**DEFENSE NUCLEAR FACILITIES  
SAFETY BOARD**

January 20, 2012

## Staff Issue Report

**SUBJECT:** Erosion/Corrosion Wear Allowances, Waste Treatment and Immobilization Plant

Figure 1. Comparison of experimentally determined wear rate data based on depth measurements with the WTP design basis wear rate for vessels with pulse jet mixers.

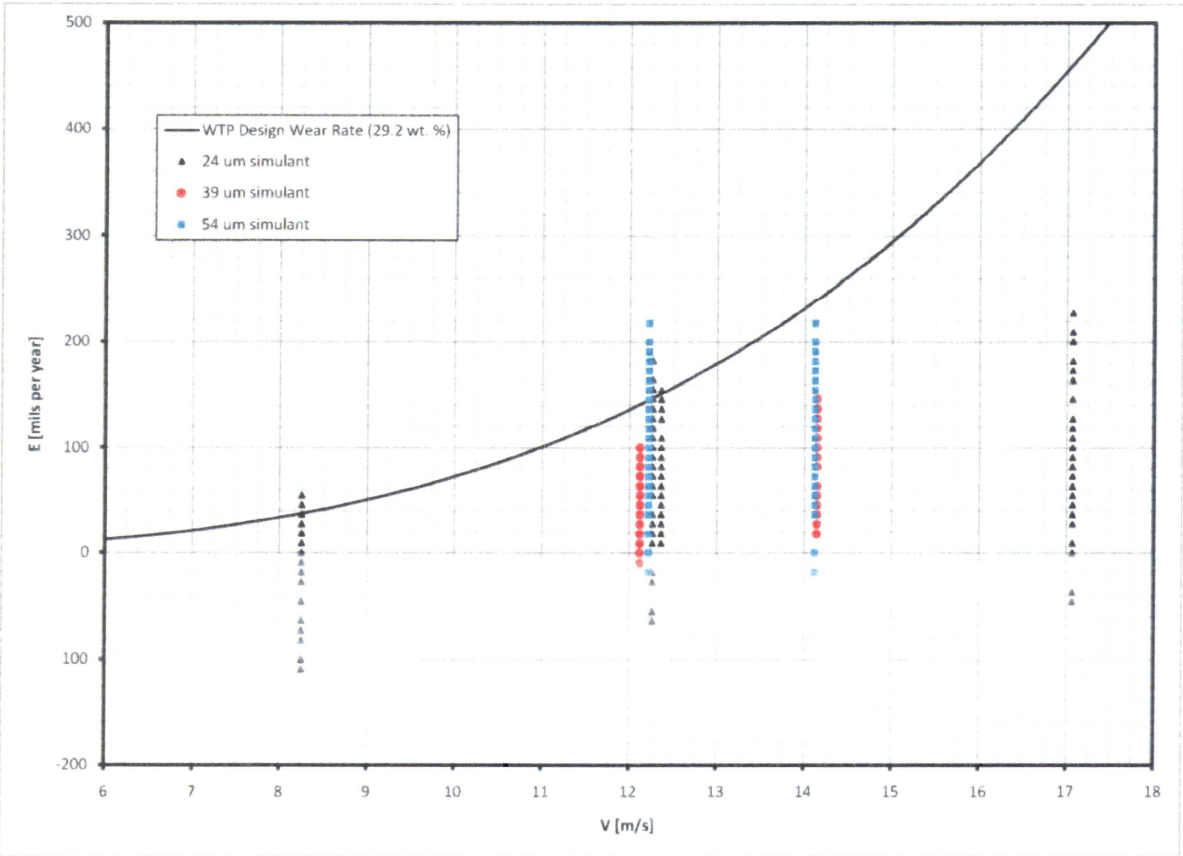
*Measured Wear Is Higher Than Design Wear Rate*—Figure 1 shows a subset of the data collected during the testing to close EFRT Issue M2. The plot shows the measured erosion rate (E) based on depth measurements as a function of velocity (V). Each datum on the plot represents the wear rate derived from depth measurements made at one of thirteen predetermined locations on each wear specimen. Each wear specimen was exposed to 96 hours of submerged

A substantial number of the localized wear data measurements for velocities of interest (8–12 m/s) for WTP PJM nozzles and vessel bottoms, including those obtained using the nonbounding but representative 24  $\mu\text{m}$  simulant, lie above the curve that defines the design basis wear rates for WTP vessels and piping. Some of the measured data are 30 percent above the design basis wear rate. Consequently, the relationship used to define design wear rates for the vessels and PJMs does not provide sufficient conservatism.

*Test Duration and Measurement Methods Cause Substantial Uncertainty*—The short-duration used for the above testing (96 hours) did not cause enough wear to permit accurate measurement of localized wear. In many cases, the resulting wear was close to or less than the accuracy of the instrument used to measure the wear. The result was unreliable measurements and, as shown in Figure 1, large data scatter. The staff analyzed the data and found that the mean difference between independent measurements performed by two different analysts was 0.23 mils with a standard deviation of 0.18 mils (which corresponds to a mean difference and standard deviation of 21.1 and 16.4 in mils per year [mpy], respectively). This error is substantial considering that, as shown in Figure 1, the expected wear for 8 m/s flow is 40 mpy.

As a further indication of uncertainty, data collected at a flow rate of 8 m/s displayed a scatter over a range of -115 mpy to +55 mpy. Data collected at 12 m/s scatter over a range of -65 mpy to +220 mpy. There is no discernable pattern or trend in the data. The experimental data that suggests a negative wear rate (gray region in Figure 1) are physically unrealistic (i.e., indicate that the wear coupons were increasing in thickness during testing).
